# Residential Appeals Committee

## STAFF REPORT

Case File Number: PLN20-164-A01

<b>Location:</b>	6142 Ruthland Road; APN: 048G-7415-031-00
<b>Proposal:</b>	Appeal of Zoning Manager's approval of development application to construct a new single-family dwelling with an Accessory Dwelling Unit (ADU) on a vacant upsloping lot
<b>Appellant:</b>	Laura Campbell (415)926-7617
<b>Applicant:</b>	Shan Masuda (415)314-3198
<b>Owner:</b>	Robert Anderson & Kimberly Clement TRS
<b>Case File Number:</b>	PLN20164-A01
<b>Planning Permits Required:</b>	Appeal of Zoning Manager's approval of Regular Design Review to construct a new single-family dwelling with an Accessory Dwelling Unit (ADU).
<b>General Plan:</b>	Hillside Residential
<b>Zoning:</b>	RH-4 Hillside Residential
<b>Environmental Determination:</b>	Categorically Exempt: Section 15303, new construction of small structures; and 15183 – Projects consistent with a community plan, general plan, or zoning
<b>Historic Status:</b>	Vacant Lot -X

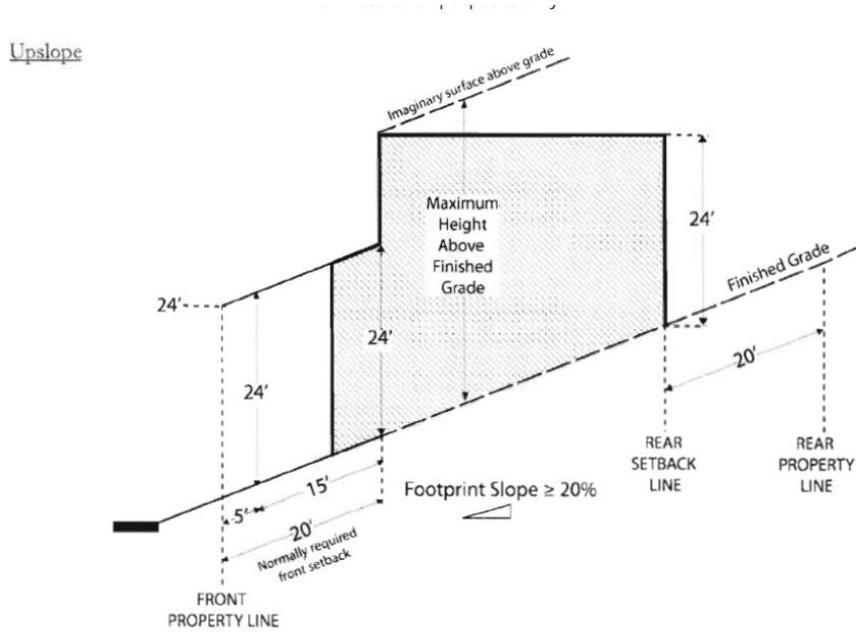
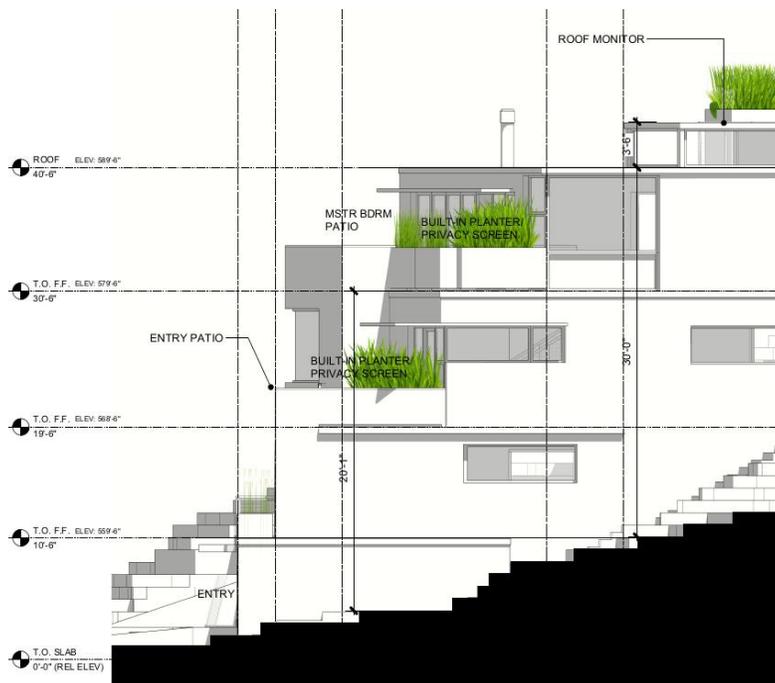
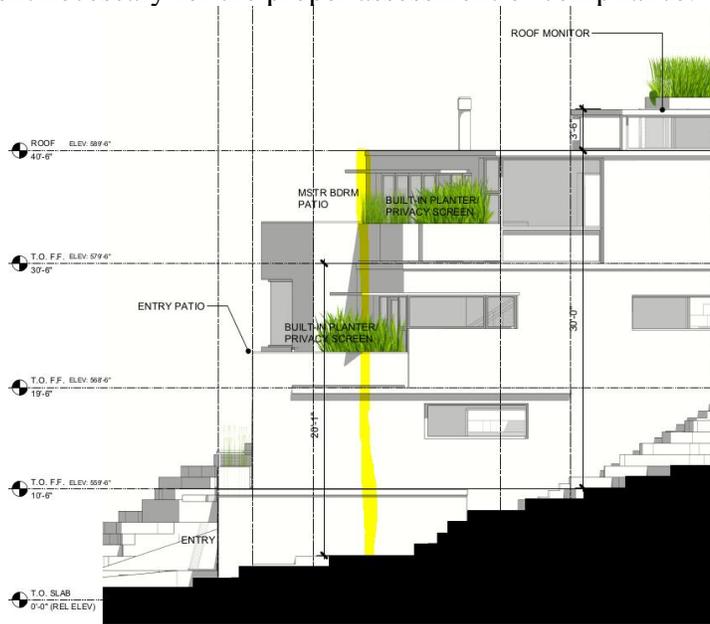
- (6) Based on the greater than 20% slope of the Property on an upslope lot, the maximum height of the structure is 32 feet. (Planning Code Table 17.13.05.) It appears the project exceeds this limit, however, the plan set does not provide enough detail to determine whether the height actually does exceed this limit.

The image below is an illustration of a proper plan set that track the finished grade and shows an imaginary surface above grade. (Id.) The maximum height from the finished or existing grade (whichever is lower) within twenty feet of the front property line cannot exceed twenty-four feet. (Planning Code Section Table 17.13.05.) The plan set does not

clearly show this detail, and the Department cannot make a determination of compliance until the Applicant revises these plans.

This plan set does not show necessary lines and measurements. It instead only shows floor and ceiling heights as compared to elevation. This is insufficient, needs to be corrected, and indicates a structure that is potentially too tall based on the slope, violating the maximum height limit.

By means of example, in the image below, the highlighted line indicates a missing measurement necessary for the proper assessment of compliance:

The illustrations are (either intentionally or unintentionally) missing key data points which render it impossible to confirm full height compliance, possibly in a manner intended to obfuscate that actual heights throughout the entirety of the proposed design.

**Staff's response:** The project complies with the 24/32-foot height limit and building envelope. Attachment “C” includes an illustration that clarifies how the project complies with the height limits.

**SECTION**

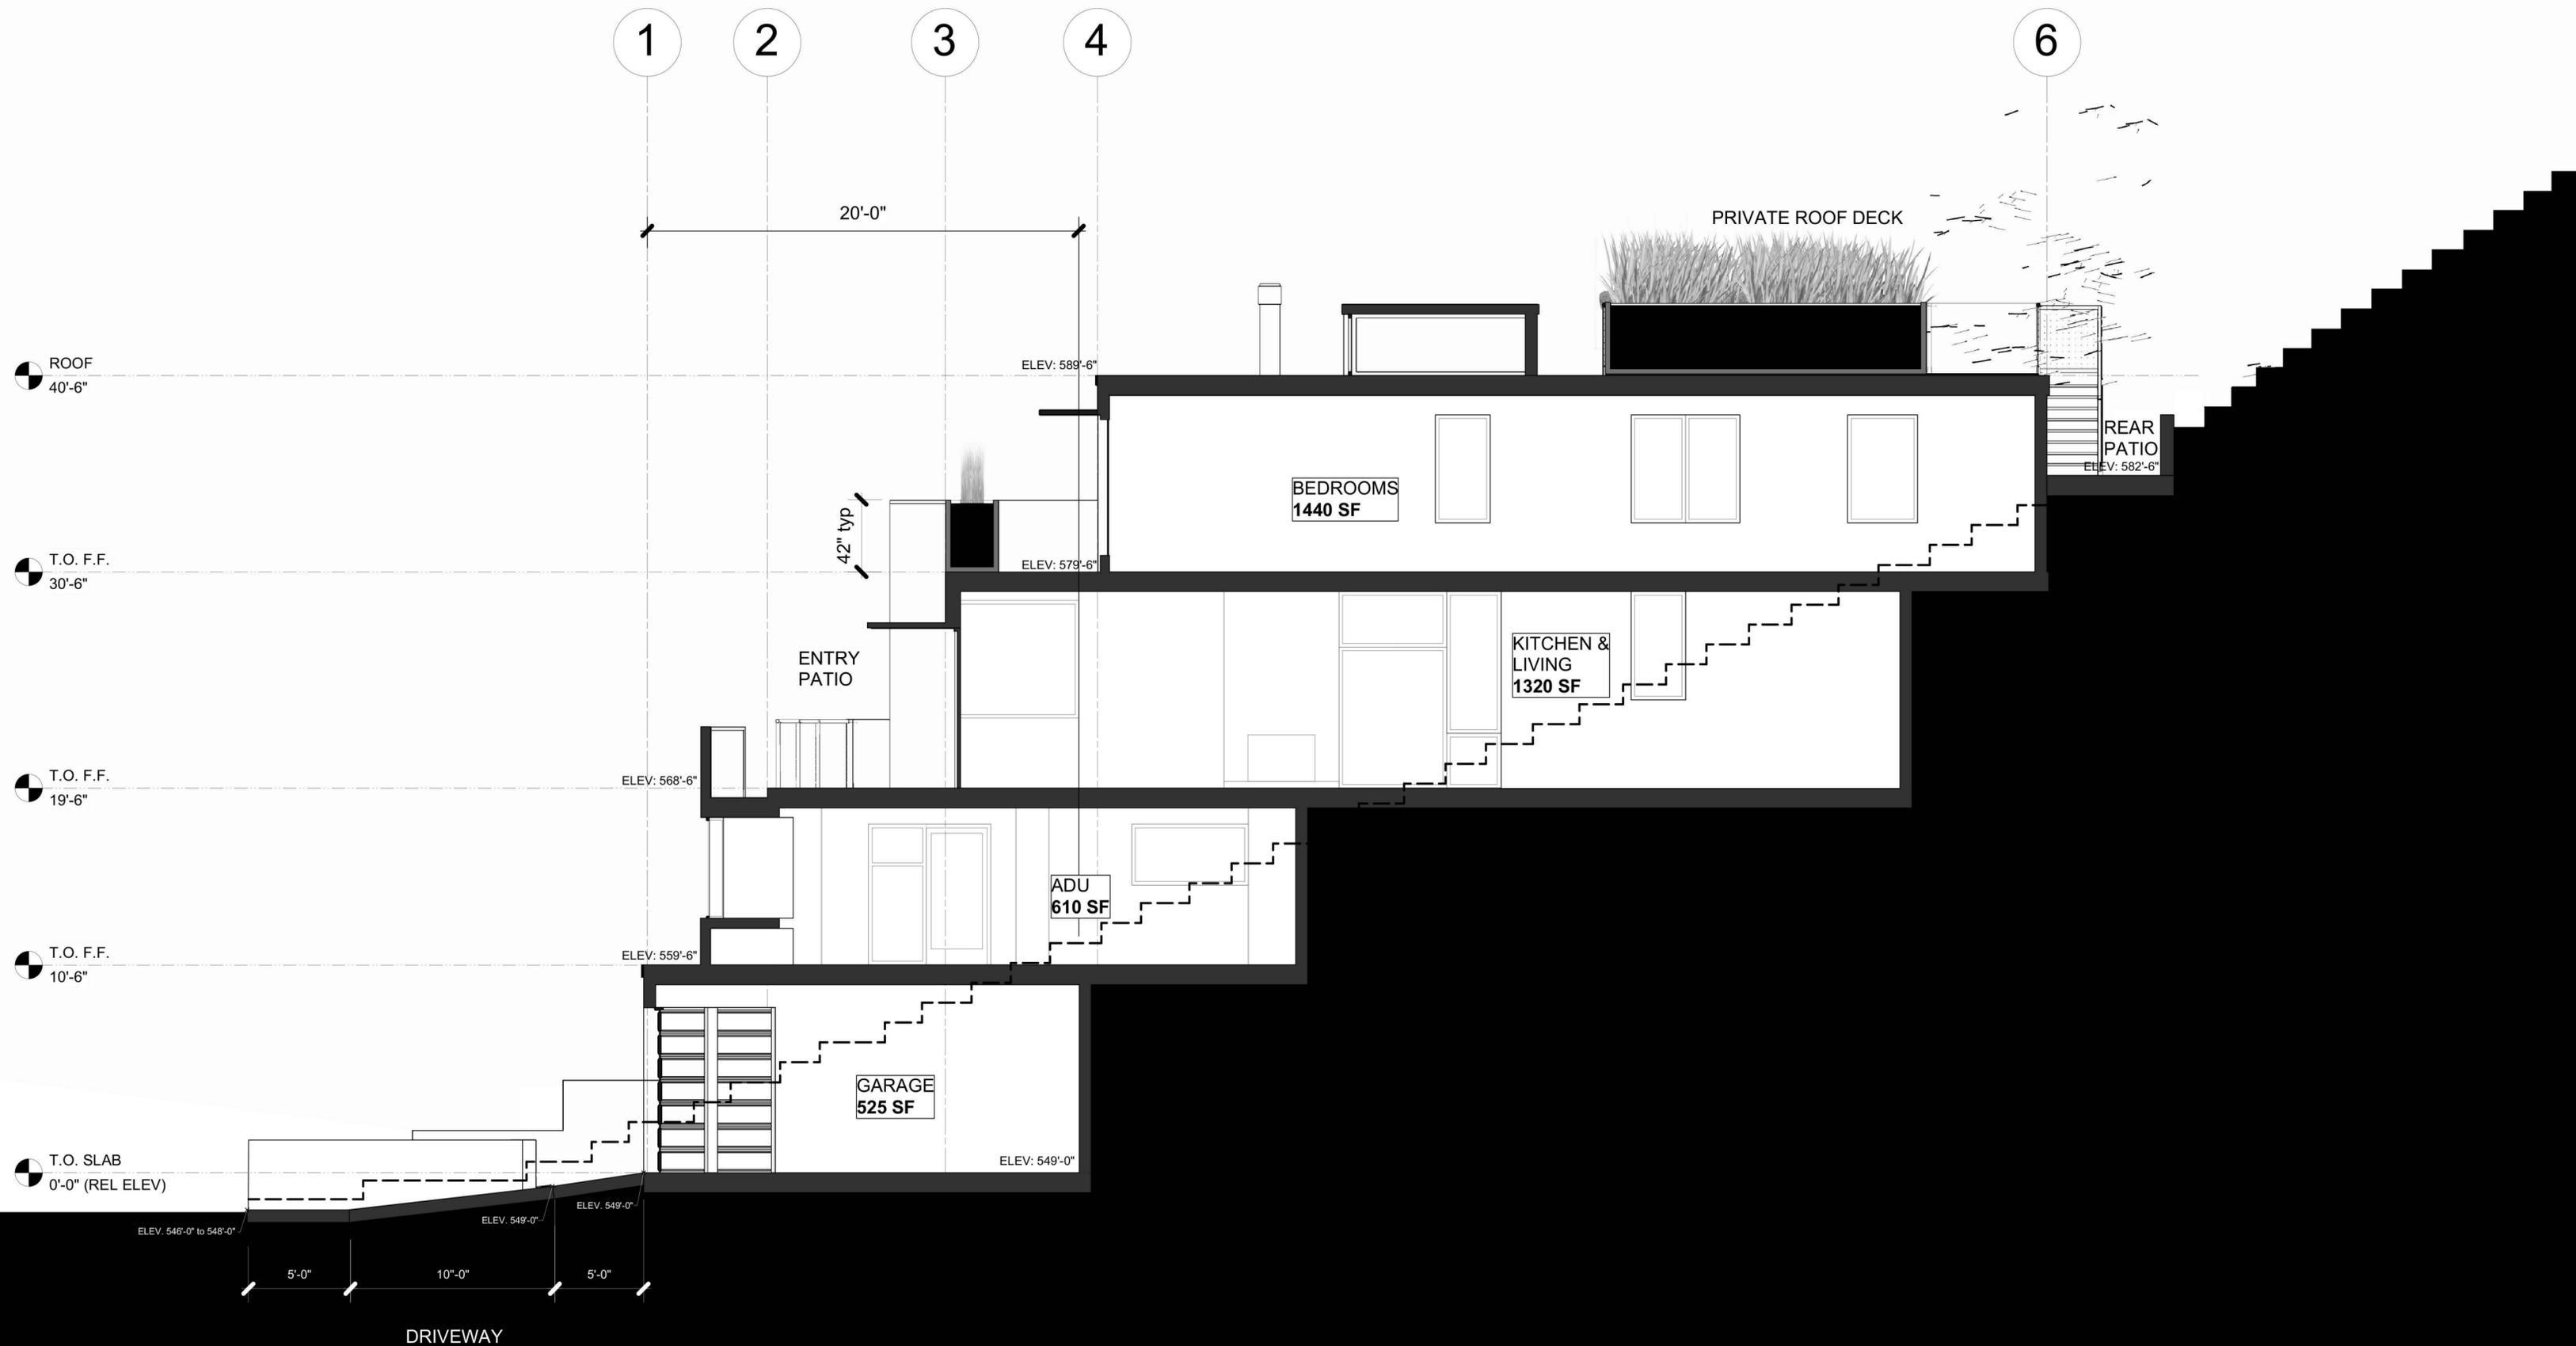
- (6) Based on the greater than 20% slope of the Property on an upslope lot, the maximum height of the structure is 32 feet. (Planning Code Table 17.13.05.) It appears the project exceeds this limit, however, the plan set does not provide enough detail to determine whether the height actually does exceed this limit. The image below is an illustration of a proper plan set that track the finished grate and shows an imaginary surface above grade. (Id.) The maximum height from the finished or existing grade (whichever is lower) within twenty feet of the front property line cannot exceed twenty-four feet. (Planning Code Section Table 17.13.05.) The plan set does not clearly show this detail, and the Department cannot make a determination of compliance until the Applicant revises these plans.
